**S.R. 206 AND ROSEMARK RD. ROUNDABOUT
TOWN OF ATOKA, TIPTON CO., TN**

ADDENDUM NO. 1

Issued: July 6, 2020

Straight-Turn Arrow Detail

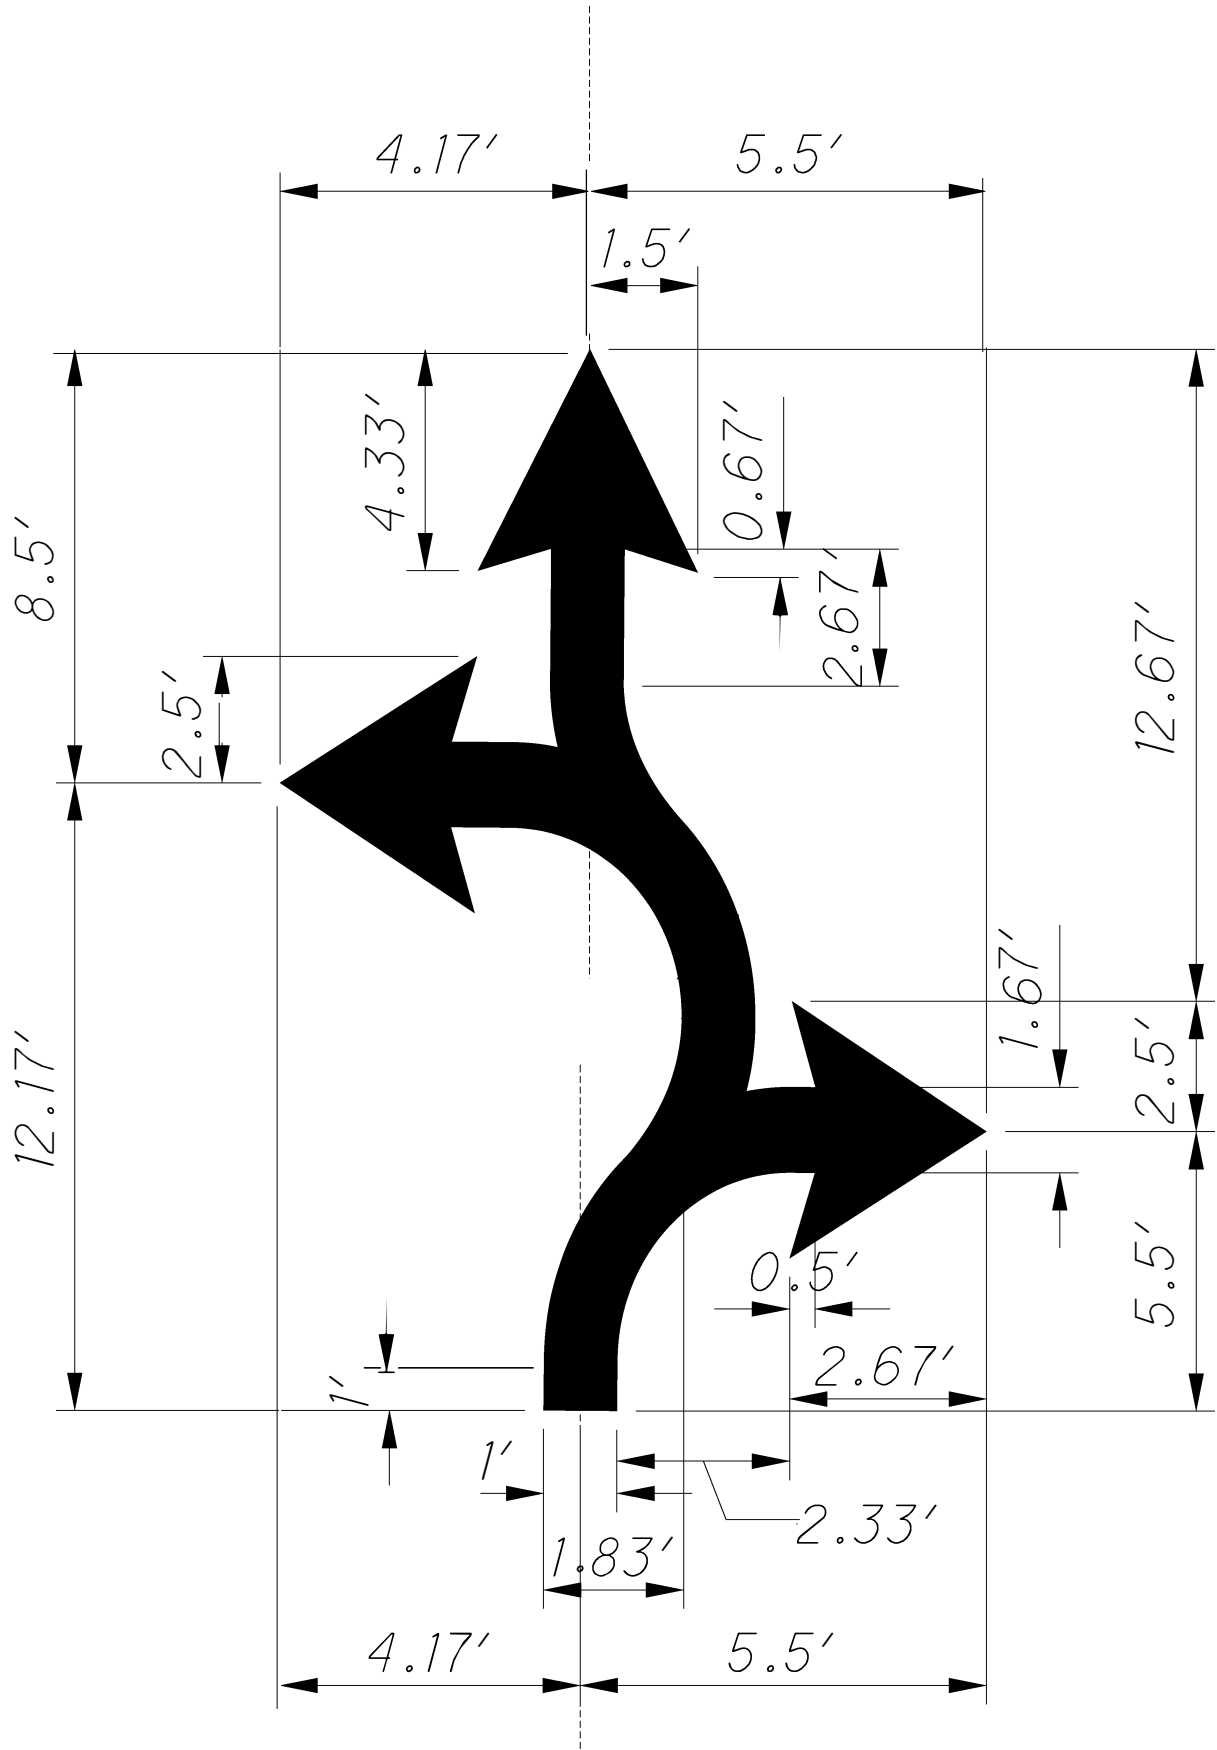
ITEM 3. Add the attached Straight-Turn Arrow detail to Pavement Marking Plan, Sheet 12, for item 716-04.01 PLASTIC PAVEMENT MARKING (STRAIGHT-TURN ARROW).

1. **Question:** For the roundabout, can you provide a typical drawing for the 'straight turn arrow', Bid Item 716-04.01? He said on a recent roundabout that he striped in Jackson, TN there was a specialty arrow for the roundabout and wondered if this project would have anything similar. It was more expensive than a normal straight arrow and he's requesting details to make sure he's covered.

Answer: See Clarifications and Modifications to Bid Documents, Drawings, ITEM 3.
